REQUEST FOR INFORMATION **DATE:** May 16, 2016 **NO.:** RFI-083

Project Name: Webster University Interdisciplinary Science Building Project No.: 15051

Subject: Curtain wall structural clarifications

2 3D VIEW - SW CORNER

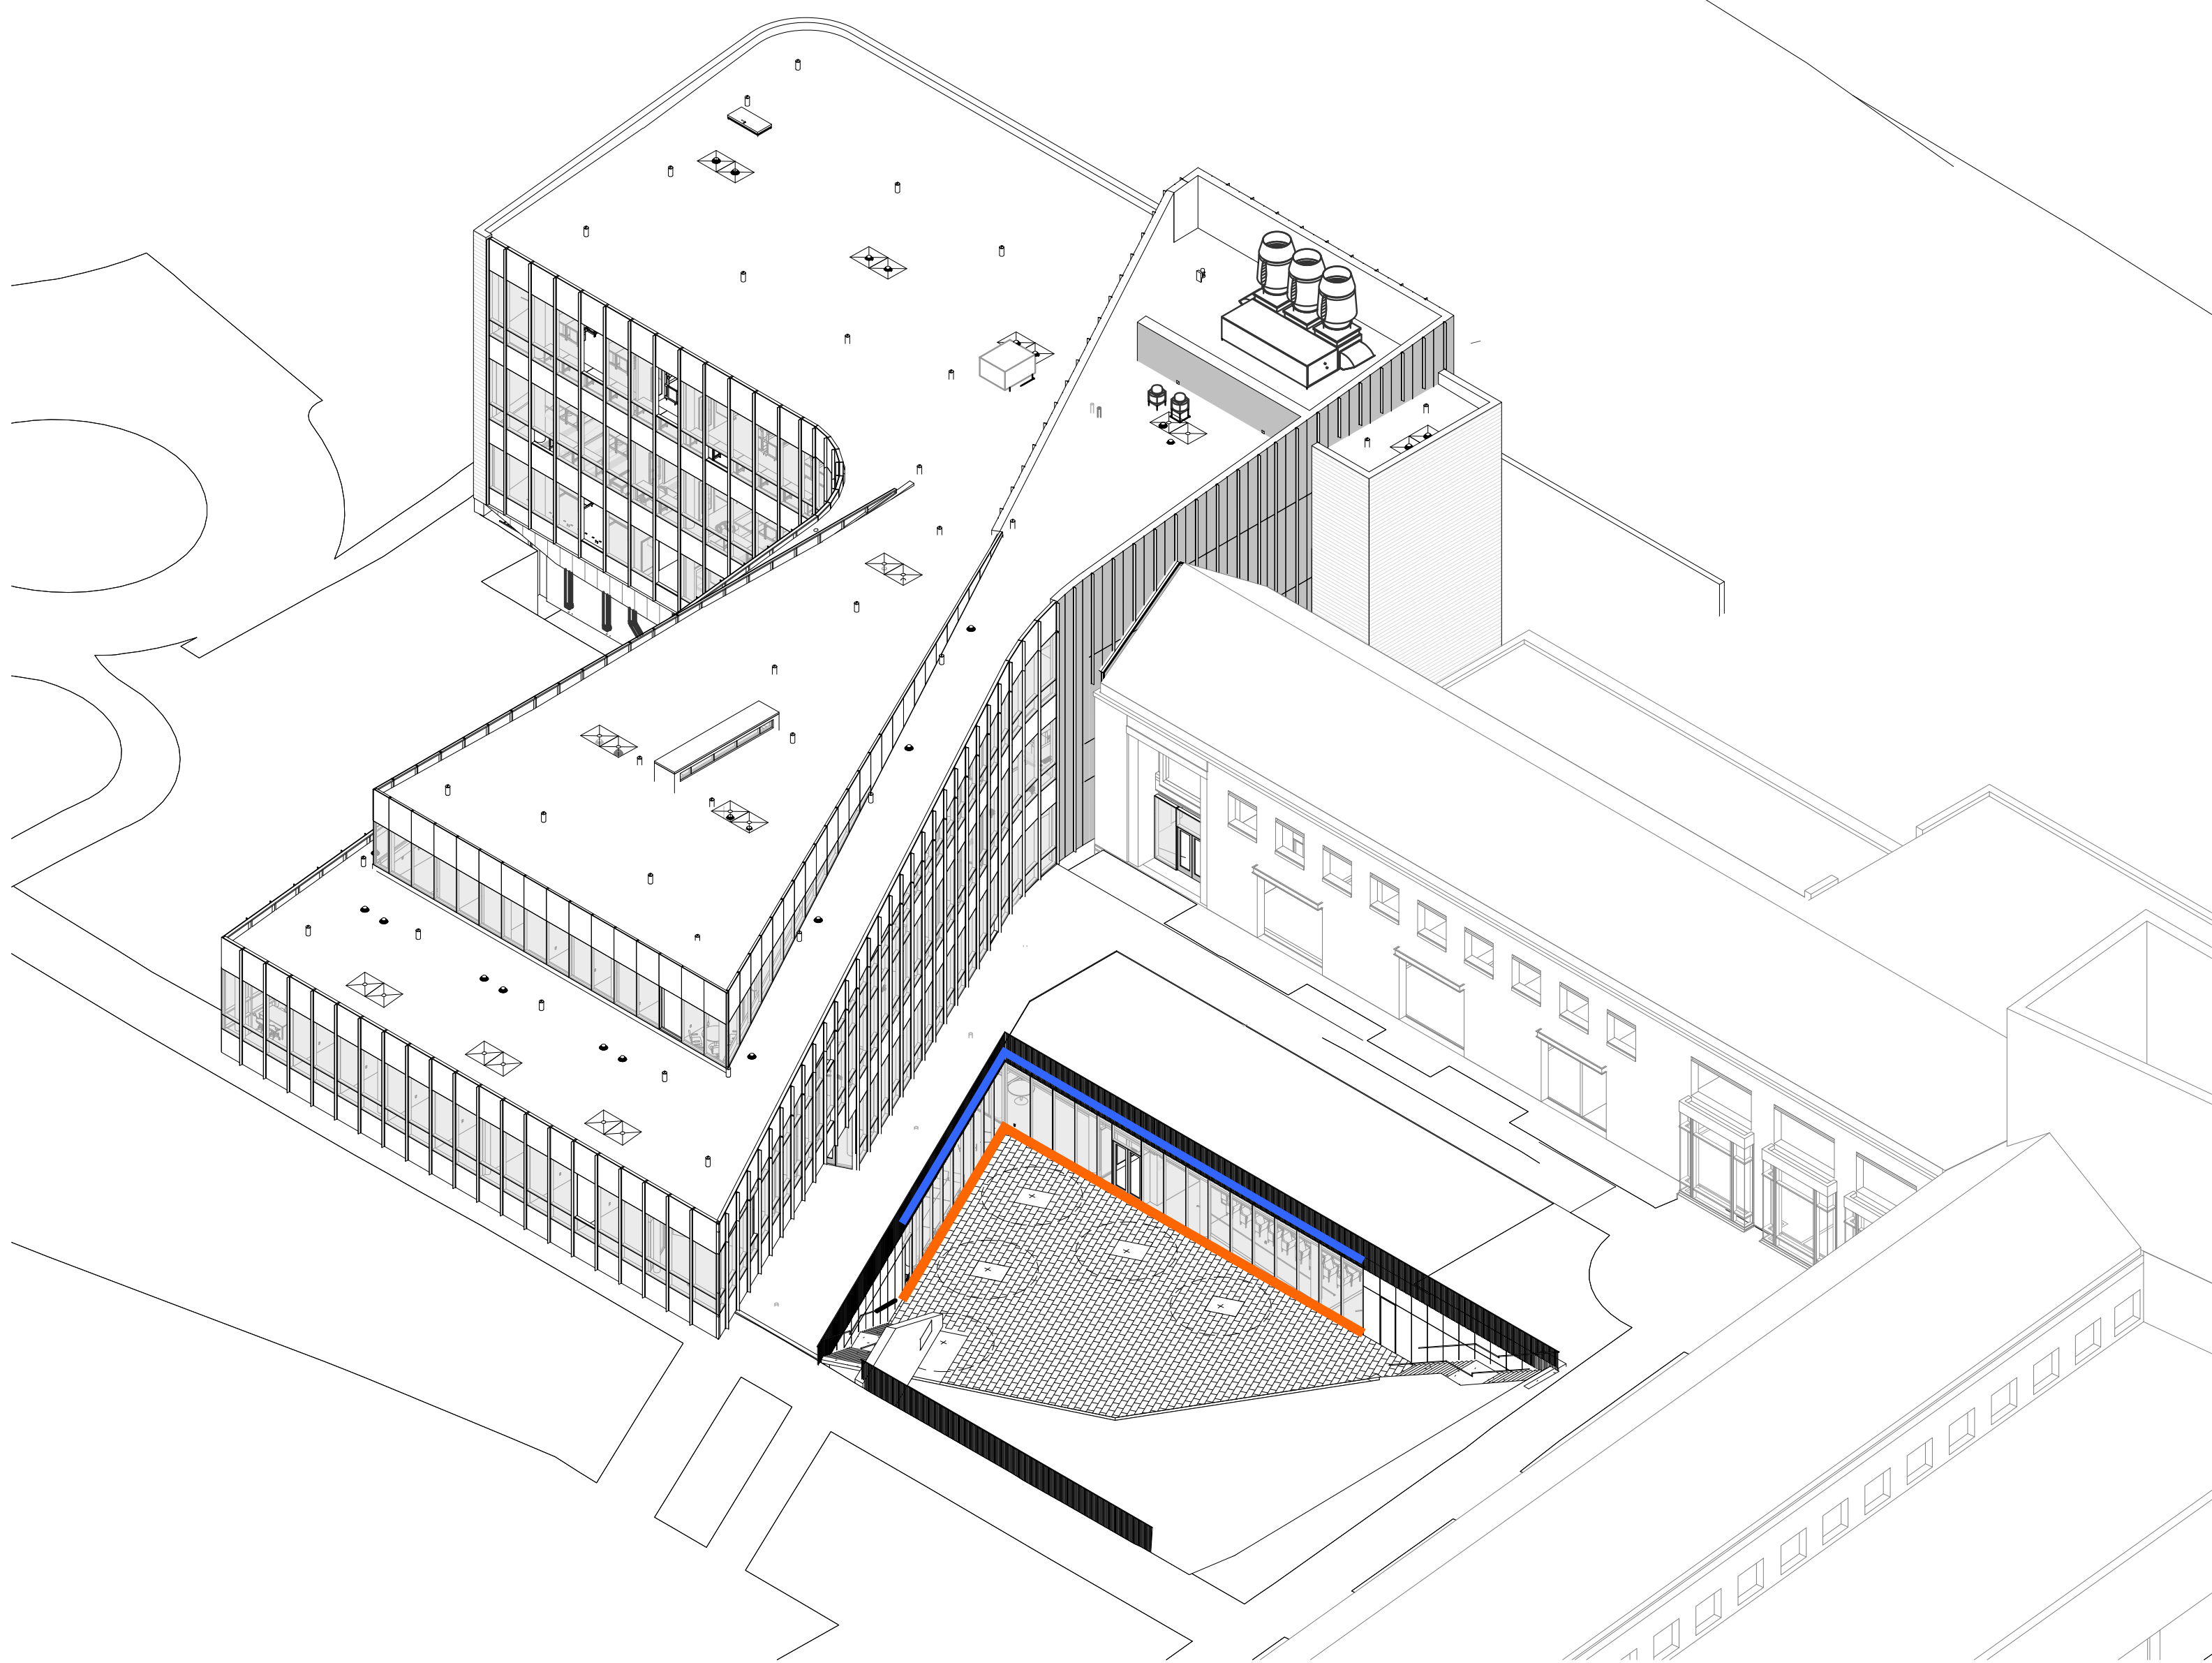
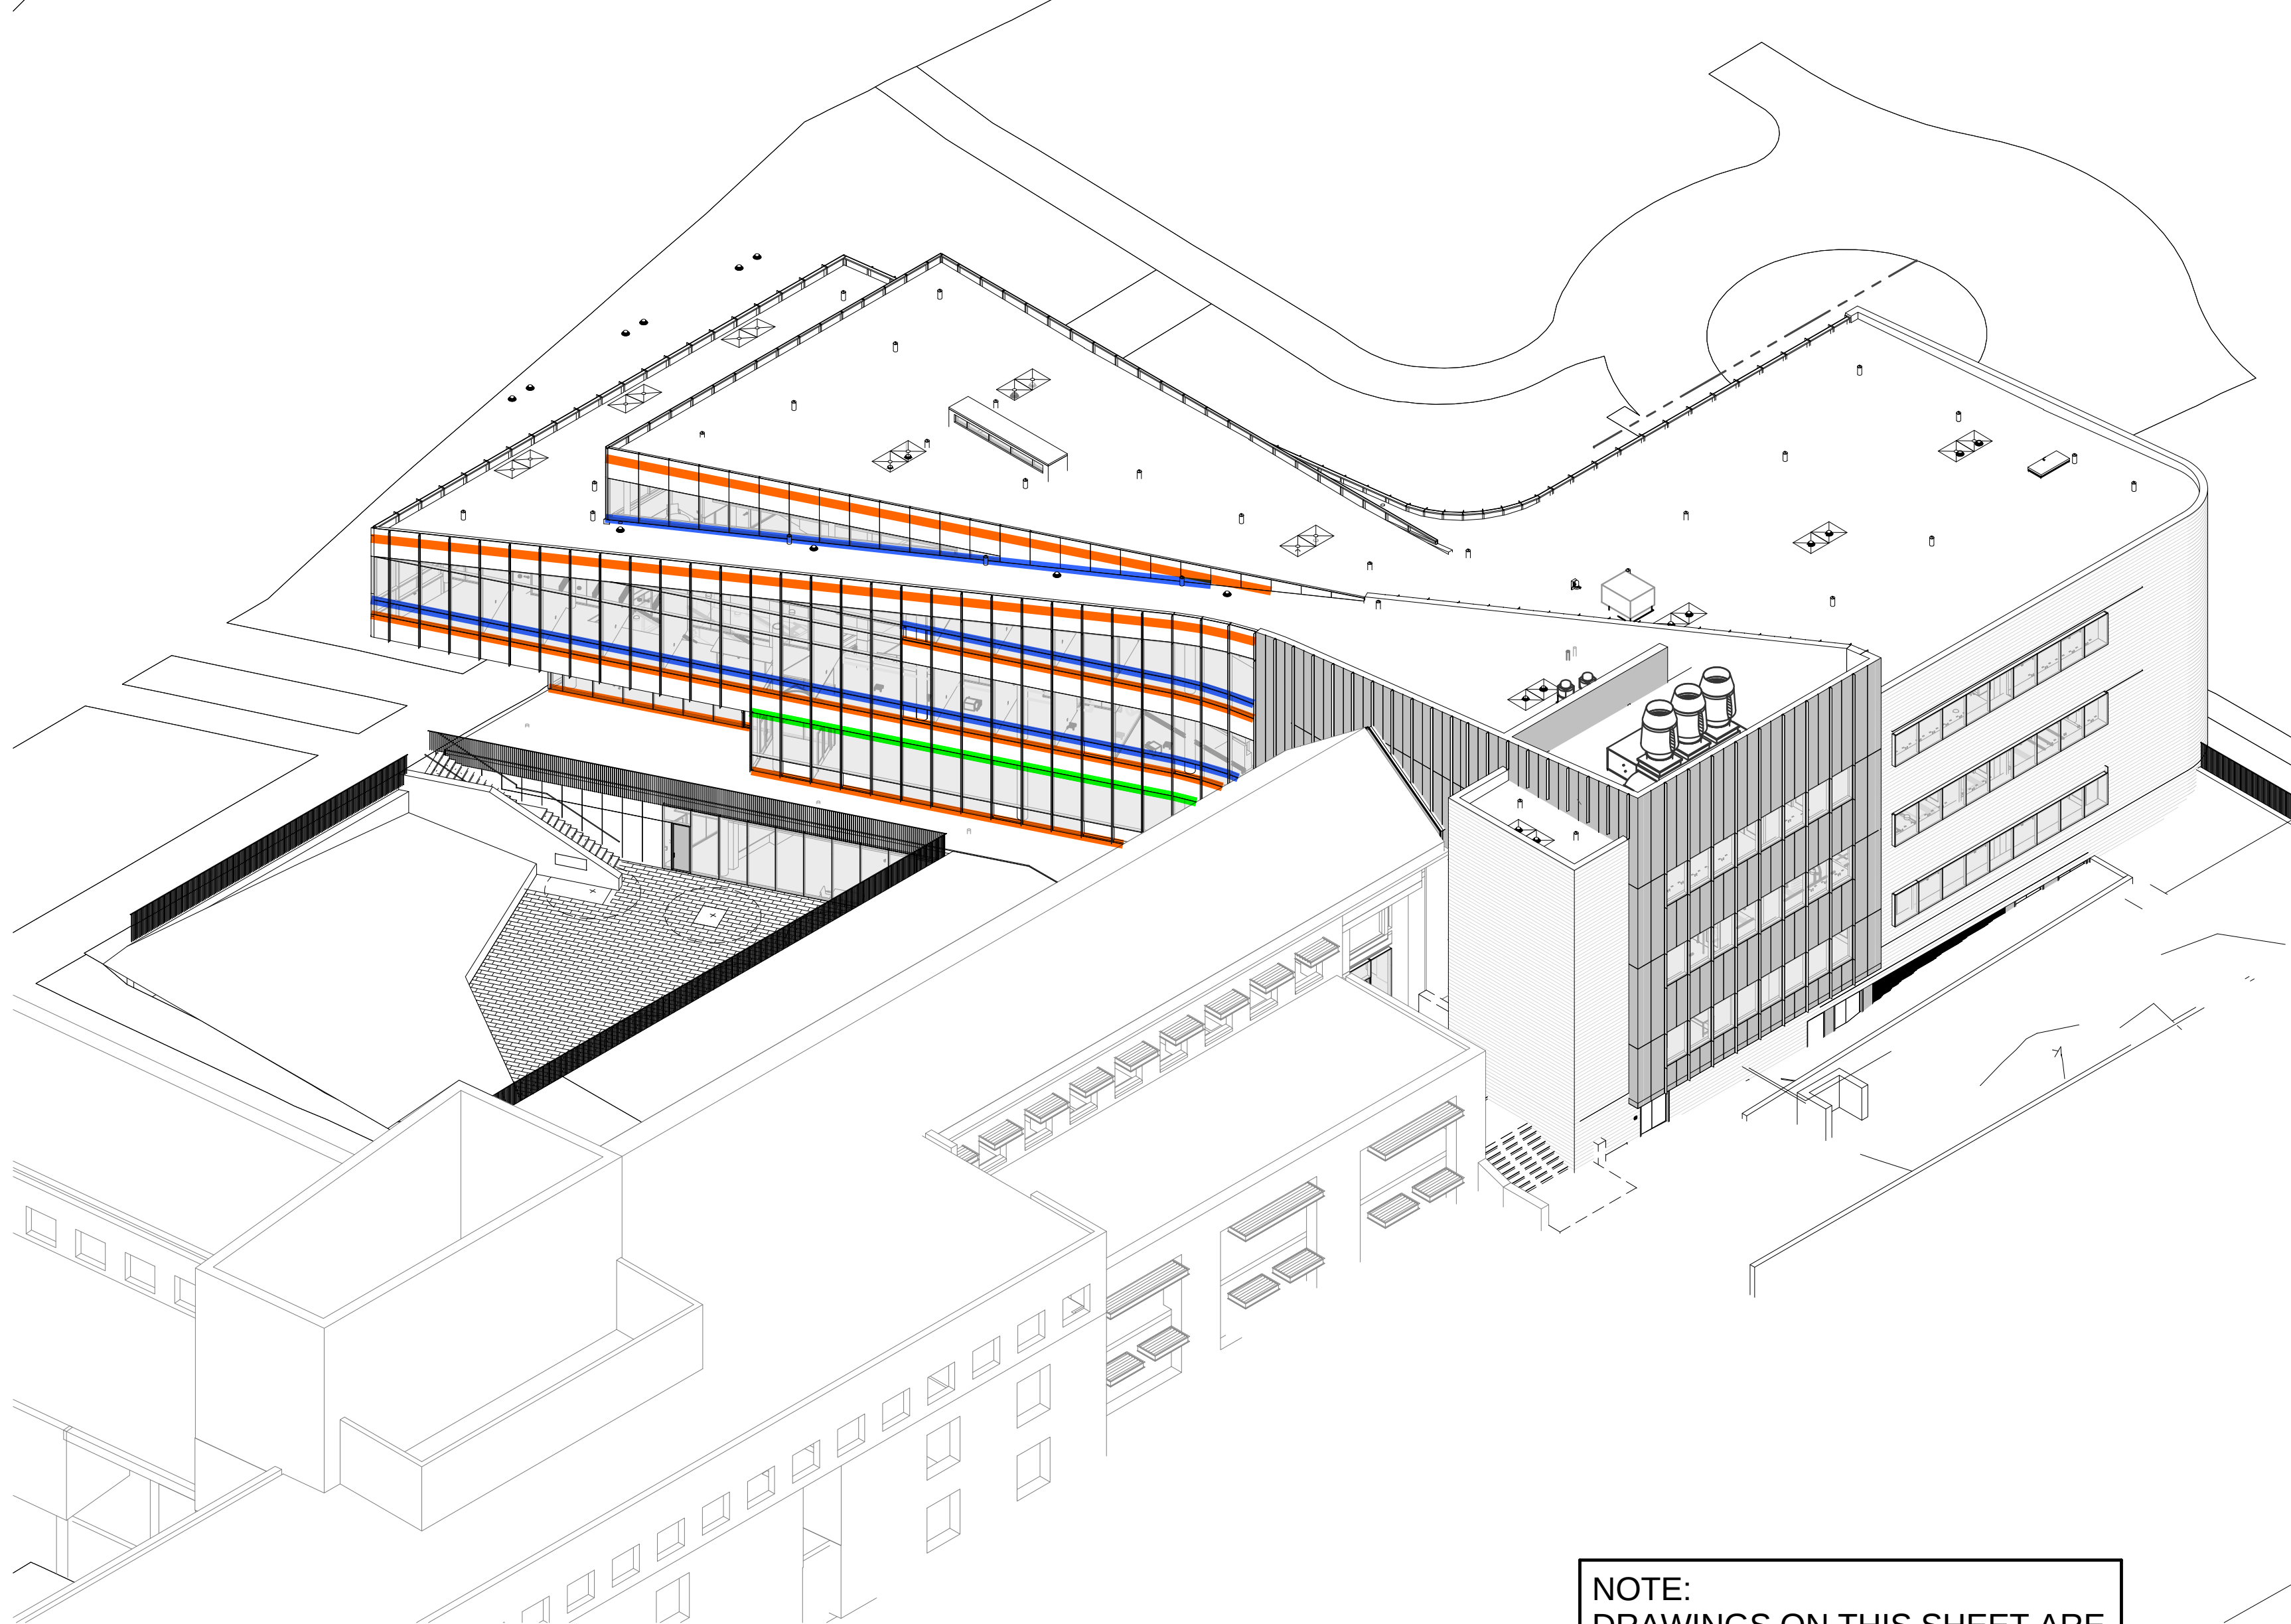
IS VERTICAL JOINT REQUIRED HERE, EACH SIDE, IF HUNG AT THE PROPOSED RED LINES?

Due to stack joint locations, 4th floor not supported as currently drawn.

Differential movement concerns with supporting the weight of these two portions at different floor lines.

6/A0452, 5/A0456 shows wind load connection. Weight of curtain wall not supported.

The stack joint is currently shown above the lateral load connection point, which is not possible, without anchor above it.

Red lines denote location where system weight would be supported

IF ADDITIONAL WALL WEIGHT IS PROPOSED FOR THE ROOF BEAMS, A DESIGN REVIEW AND POTENTIAL ROOF BEAM REVISIONS MAY BE REQ'D
